Comment Submission

Project: DOI-BLM-UT-Y010-2024-0029-EA - Dolores Travel Management Plan

Submission ID: DoloresTMP-1-500707105

Dolores River Routes

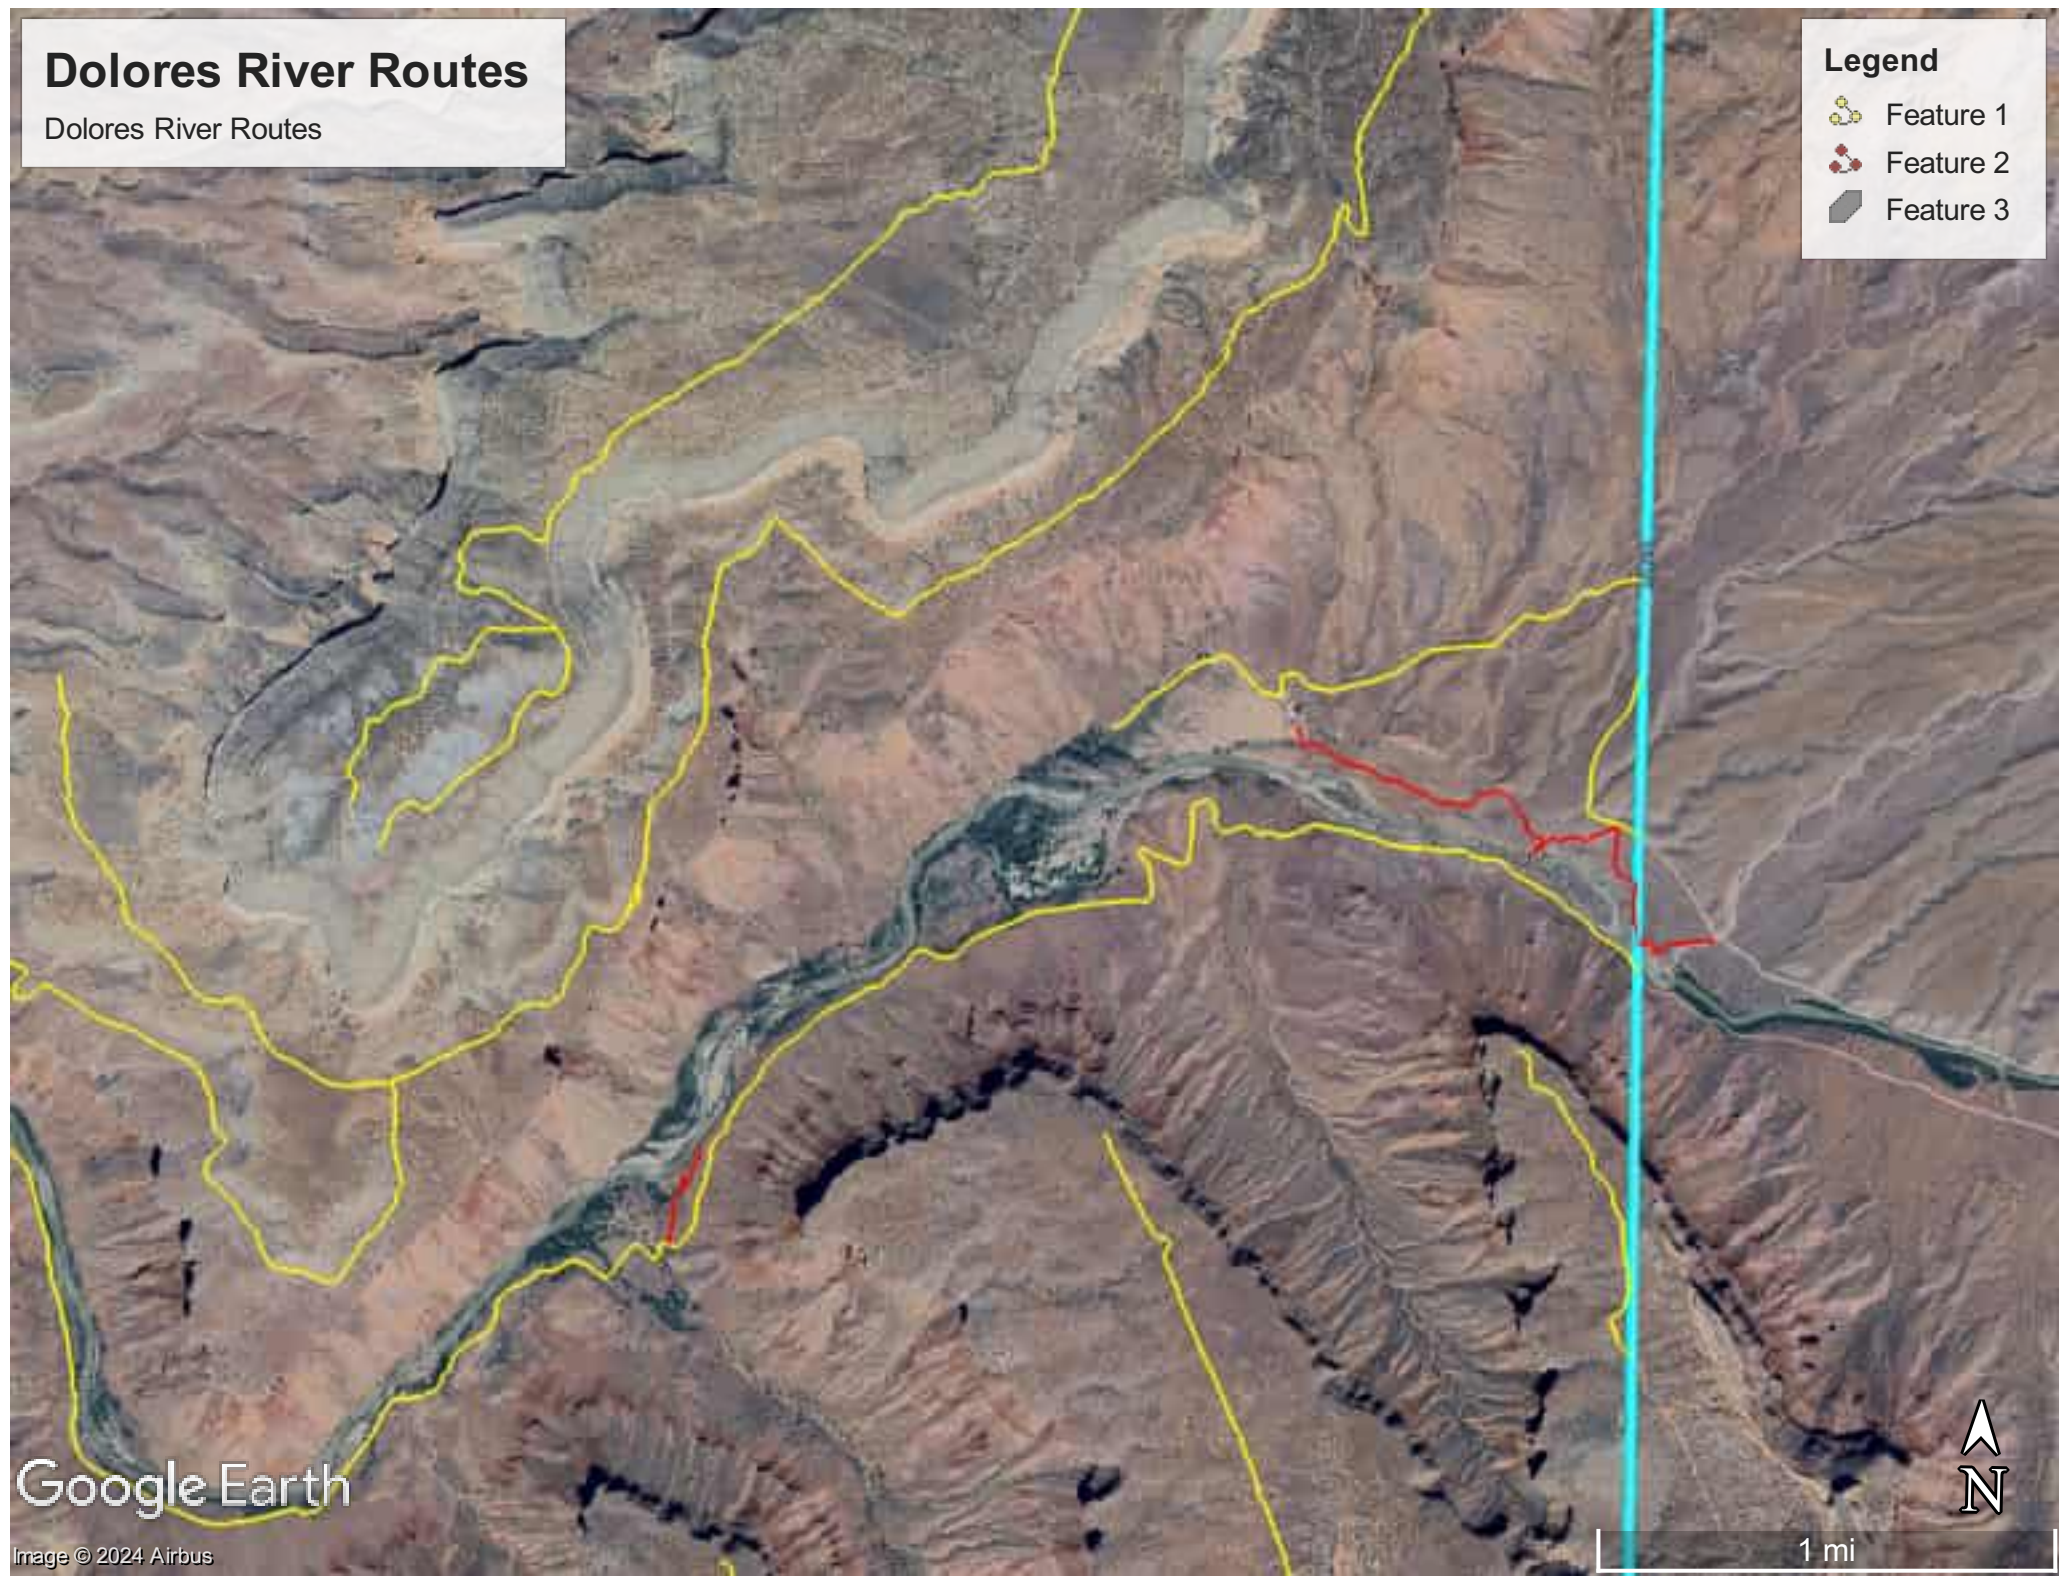
There are missing routes in the inventory. I did a brief high level review of the TMA area and quickly found 9 routes that are missing from the inventory using satellite imagery. Further ground proofing is necessary to determine other routes.

Pdfs are attached to show the locations, a kmz file is available to show precise locations by contacting the submitter.
